# Errata

## SLG46826

### CE-GP-015

*This document contains the known errata for SLG46826 and the recommended workarounds.*

Figure 1: Example Data

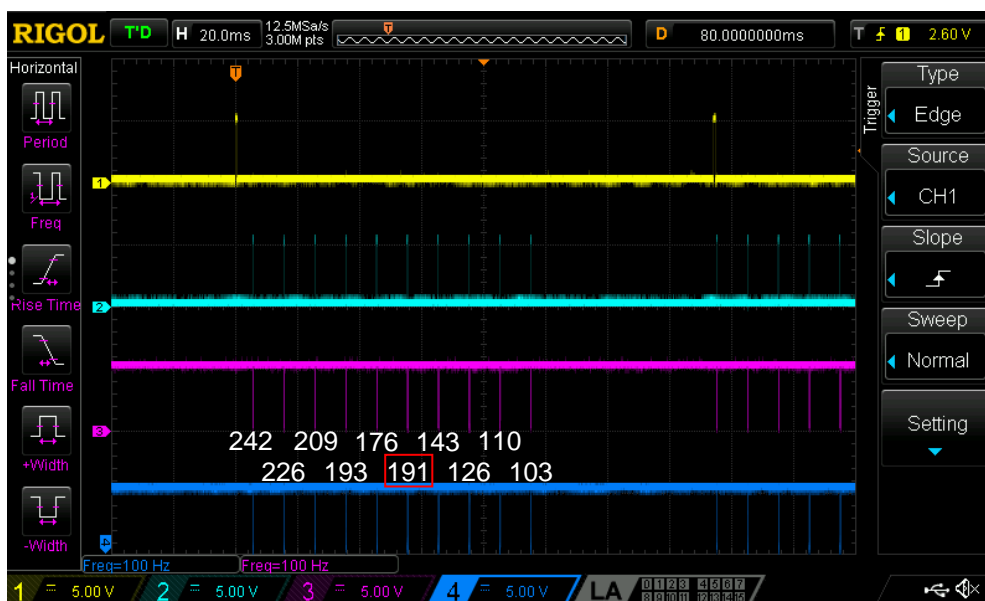
Asynchronous interaction between the CNT/DLY clock input and the I<sup>2</sup>C latch signal (generated by an I<sup>2</sup>C read command of the CNT/DLY block's count value) can result in an incorrect I<sup>2</sup>C data read. The CNT/DLY block will count accurately, but the count value transferred into the block's I<sup>2</sup>C read register might be loaded incompletely if the I<sup>2</sup>C latch signal and the clock input occur at about the same time.

The example data capture below shows ten periodic I<sup>2</sup>C reads of CNT2/DLY2 configured to count down at about 16 clocks per read. The sixth read sample erroneously shows a value greater than that of the fifth. The seventh sample reads as if the previous I<sup>2</sup>C error never occurred - the difference from the fifth sample (176) to the seventh (143) is 33 clocks or 16 clocks + 17 clocks as expected.

If the possibility of incorrect I<sup>2</sup>C data reads can't be accommodated for by external software checks, one can guarantee proper operation by stopping the CNT/DLY block's clock during I<sup>2</sup>C reads through one of the following methods: by disabling the oscillator block, by reconfiguring the CNT/DLY block's clock source, or by gating an external clock using a LUT (Look Up Table) in the signal matrix. After disabling the CNT/DLY block's clock, the count registers can be read without error. Please note that this workaround will add the I<sup>2</sup>C read and processing time to the counter's overall clock period.

The best workaround depends on the resource constraints of the application. If the oscillator block doesn't clock other logic elements within the design, a matrix output can be used to manually power down the oscillators for the I<sup>2</sup>C read. When the CNT/DLY block's clock source is routed internally from the oscillator block, I<sup>2</sup>C commands can temporarily reconfigure the CNT/DLY block's clock source registers to select "Ext. CLK. (From Matrix)." This action will disable the clock by connecting it to ground. If the CNT/DLY block is clocked from the signal matrix, the LUT can be used to gate the clock during the I<sup>2</sup>C read.

Figure 2: GreenPAK I<sup>2</sup>C Write Frame for Page Erase

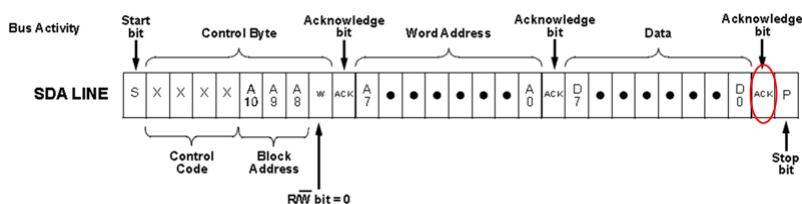
To erase the NVM and the EEPROM, one must perform an I<sup>2</sup>C write to the "Page Erase Byte" located at 0xE3. The ACK bit which follows the "Data" portion of [Figure 2](#) won't comply with standard I<sup>2</sup>C specifications. Please see the ACK bit circled in RED below.

No workaround is required for the GreenPAK device as the NVM and EEPROM erase operations will execute properly. For verification, one can perform an I<sup>2</sup>C read of the erased pages. Excluding protected pages, all erased NVM and EEPROM registers should be cleared.

Adjust the MCU’s I<sup>2</sup>C firmware to catch and ignore a “NACK” from the GreenPAK device when the “Page Erase Byte” is addressed. In light of the additional STOP and START conditions, the behavior of other I<sup>2</sup>C slaves on the same bus should be evaluated.

Figure 3: Non-I<sup>2</sup>C Compliant Behavior Oscilloscope

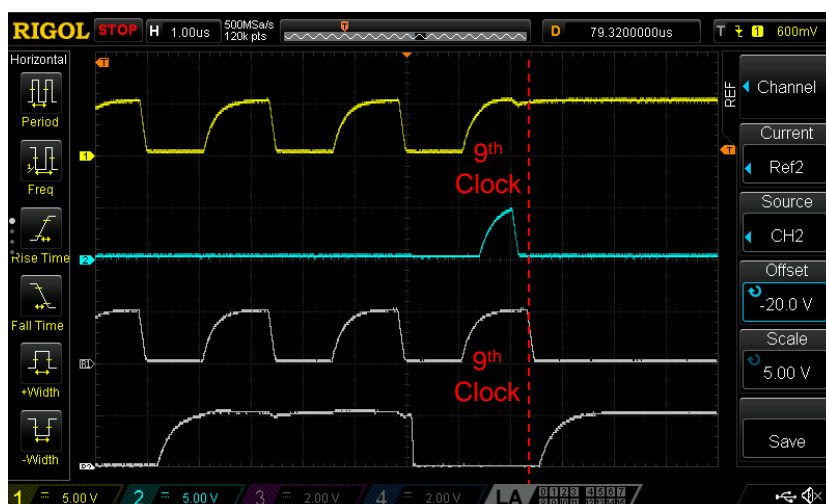
The following waveform compares the regular I<sup>2</sup>C ACK behavior (Ref 1 - SCL and Ref 2 - SDA) with the non-compliant ACK behavior (Channel 1 - SCL and Channel 2 - SDA) generated by an I<sup>2</sup>C write to the “Page Erase Byte.” During the 9<sup>th</sup> clock cycle, the SLG46826 does not adhere to the “data hold time” specification by releasing SDA (Channel 2) before the falling edge of the clock pulse on SCL (Channel 1).

On a system level, other I<sup>2</sup>C devices might interpret this non-compliant ACK as an additional STOP and START condition. By definition, a START condition occurs when SCL is HIGH and SDA transitions from HIGH to LOW. A STOP condition occurs when SCL is HIGH and SDA goes from LOW to HIGH. After the 9<sup>th</sup> clock cycle, the MCU should generate the final STOP condition to indicate the end of transmission to all I<sup>2</sup>C slaves on the bus.

**Figure 4: GreenPAK Input Structure Test Schematic**

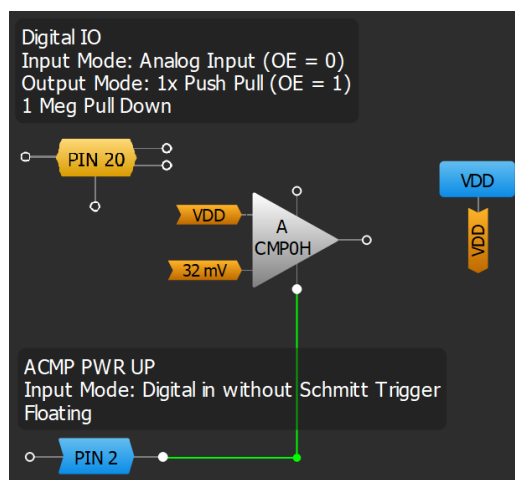
Figure 4 shows the GreenPAK configured with IO14 as a Digital IO with a 1 M $\Omega$  pull-down resistor. Since the OE pin is connected to 0 V, this pin is acting as an “Analog IO.” As seen in Table 2, IO14 and V<sub>DD</sub> are both input options for ACMP0H. In this example, IO0 is being used as a digital input to enable and disable the ACMP.

There is no workaround for this behavior. With this in mind, the IOs should not be used as digital IOs (with "Input mode" set to Analog input) or as digital outputs (with "Output mode" set to 1/2/4x 3-State Output) if the respective ACMP is enabled and connected to another input source.

Figure 5: ACMP Input Structure Behavior

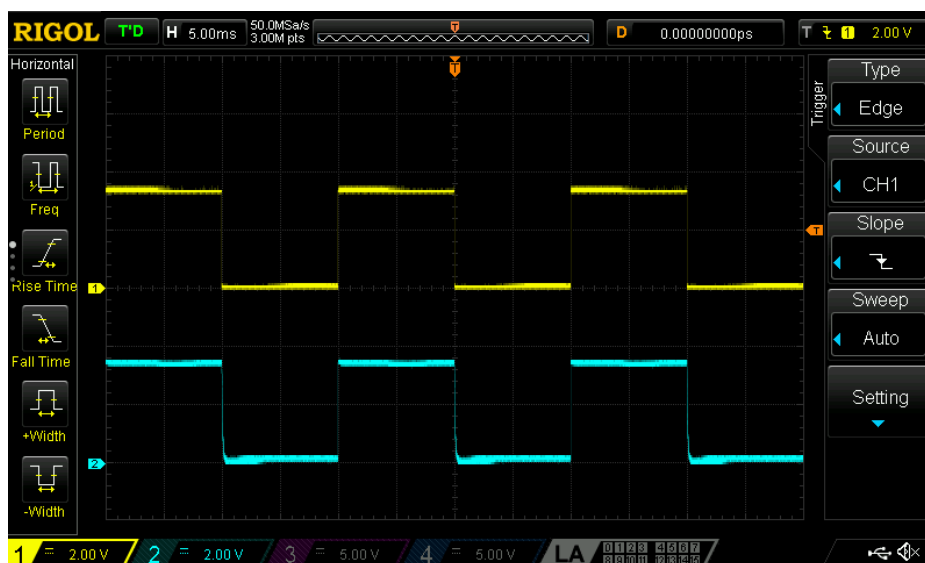
Figure 5 shows that IO14 in analog input mode is pulled HIGH by the V<sub>DD</sub> signal whenever the ACMP is enabled despite having an internal pull-down resistor. This behavior is caused by an internal connection between V<sub>DD</sub> and IO14. Similar behavior can be reproduced when one ACMP’s IN+ port is connected to another ACMP’s IN+ port.

Figure 6: Testing Design

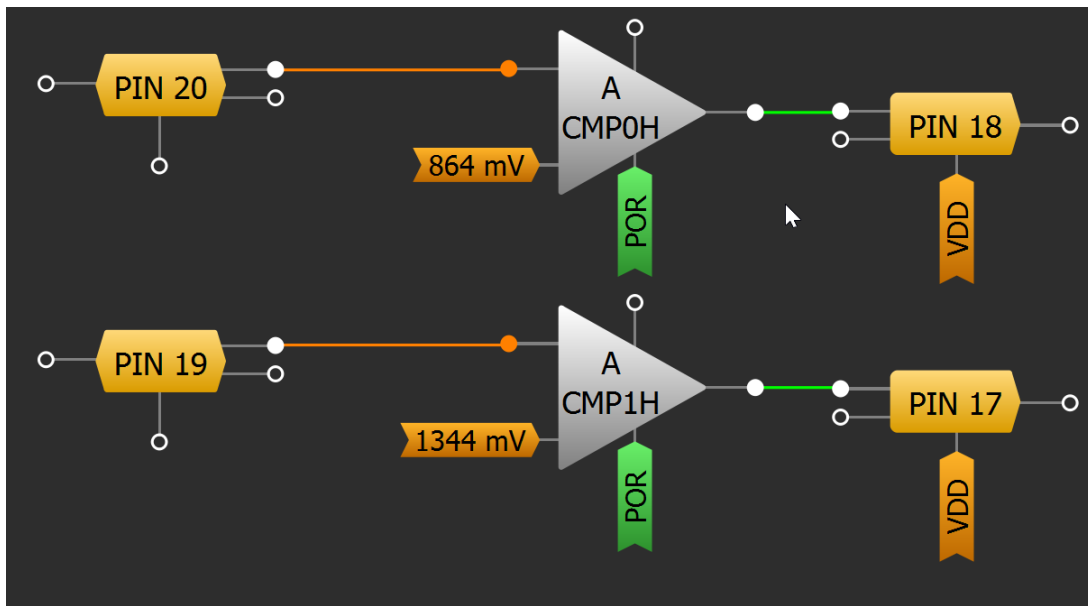
If using ACMP with 32 mV hysteresis, ACMP output could be glitching when ACMP positive input (IN+) is close to the negative input (IN-). It can happen when  $V_{DD} = 4.0$  V or higher and  $V_{ref}$  ranges from 0.832 V to 1.024 V, and 1.312 V to 1.44 V.

1. Use the deglitch filter connected to the ACMP output.
2. Avoid conditions described in paragraph 3.4.2.

Figure 7: ACMP Output during Glitching

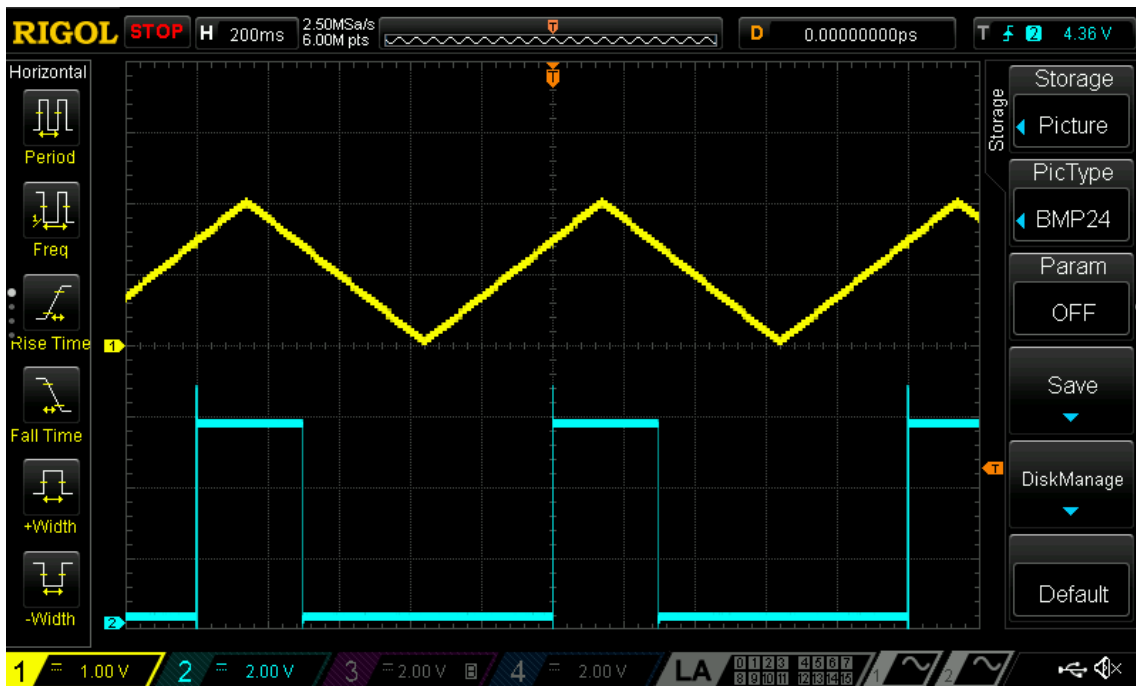
1. Waveform at  $V_{ref} = 864 \text{ mV}$ , hysteresis is equal to  $32 \text{ mV}$ .

Figure 8: Zoomed ACMP Output during Glitching

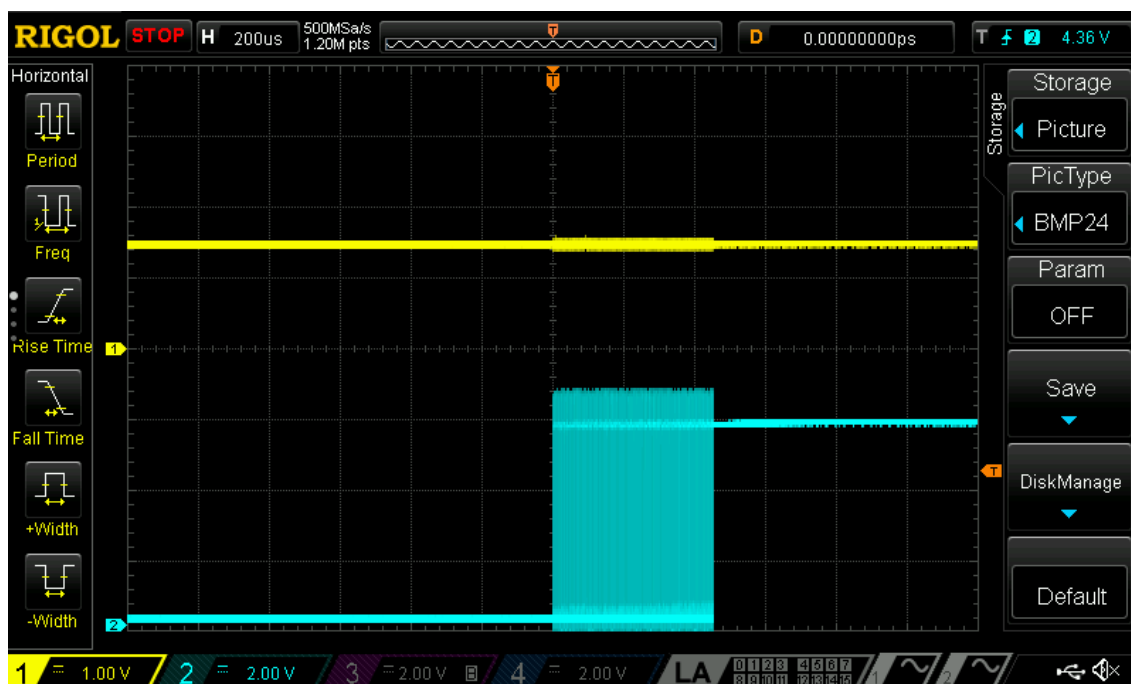
2. Waveform at  $V_{ref} = 864 \text{ mV}$ , hysteresis is equal to  $32 \text{ mV}$  (zoomed rising edge).

Figure 9: Testing Design

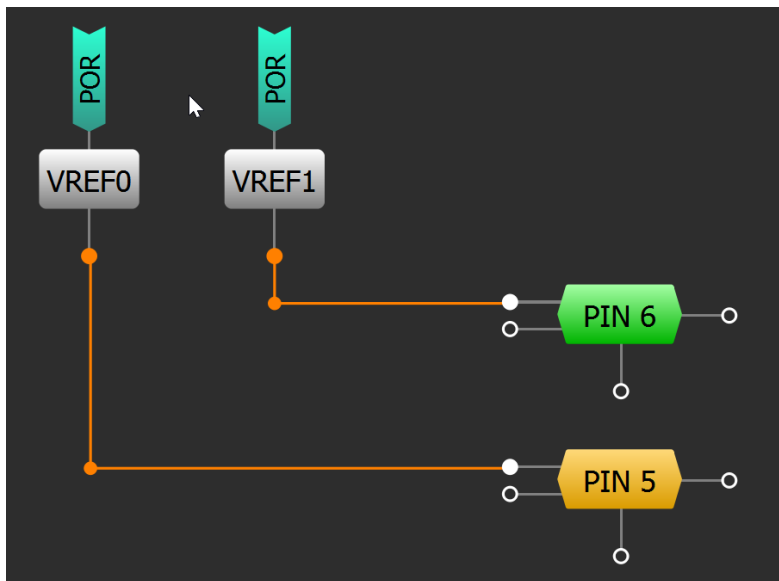
If using Vref output in the range of 32 mV to 192 mV connected to the analog input/output PIN, the Vref accuracy is very low due to the built-in buffer's offset.

There is no workaround.
